Crestview Park

Crestview Park is a large neighborhood park that provides a preschool building, parking lot, playground, sledding hill, tennis court, basketball court and ballfields. The main issues at this park are not having proper accessible parking spaces, slopes too steep, protruding branches, trash cans too far off the accessible route, gates have too narrow of clear openings, and low accessible routes that fill with water and mud. The rock program in the basement of the Recreation Building is not accessible and would require a major expense such as a lift of elevator to make it accessible. Consider relocating the program to an accessible site. **Please Note:** When a **UD** is indicated, this is a Universal Design (**UD**) recommendation to enhance accessibility. The **UD** recommendation is not required to meet the minimum accessibility standards but it would be encouraged. When engineered wood fiber is provided at playgrounds provide a regular maintenance of the surface to maintain an accessible surface.

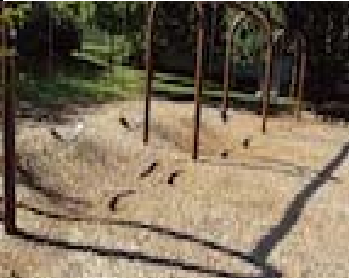
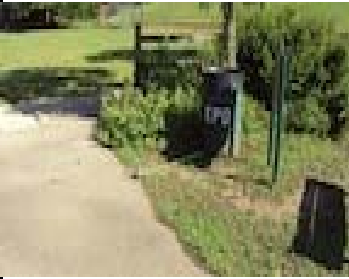
The northwest corner of the walkway along the building has a cross slope too steep at 2.6% to 5.9% for 35'.	ADAAG 403.3	Attempt a "mud jacking" technique or remove and regrade section to provide a cross slope no greater than 2%.			\$2,100	2021	
	The north entrance walkway has a running slope too steep at 5.6% to 15.6% for 14'.	ADAAG 403.3	Remove and regrade section to provide a running slope no greater than 5% and a cross slope no greater than 2%. Because of the slope in this area regrading to 5% may not be possible. Follow ADAAG 405 for ramps if necessary.			\$1,875	2021

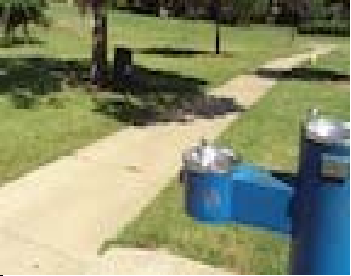
Photo	Barrier	ADAAG/IAC	Solution	Priority	By Whom	Projected Cost	Projected Date	Action Taken
	There is no accessible route to the grill for 16'.	<p style="text-align: center;"><u>Proposed</u> Outdoor Developed Areas Guidelines ADAAG 1011.5</p>	<p>Grill Recommendation: Follow Outdoor Developed Area Report that states 20% of grills, but at least two, be of accessible design, and connected to an accessible route. The accessible grill should provide a cooking surface a minimum of 15" to 34" maximum AFF above the ground surface, a clear floor space and controls that are within a maximum reach range of 48" AFF. And a 48" by 48" space centered on the usable sides of the grill is required.</p>			\$50	2024
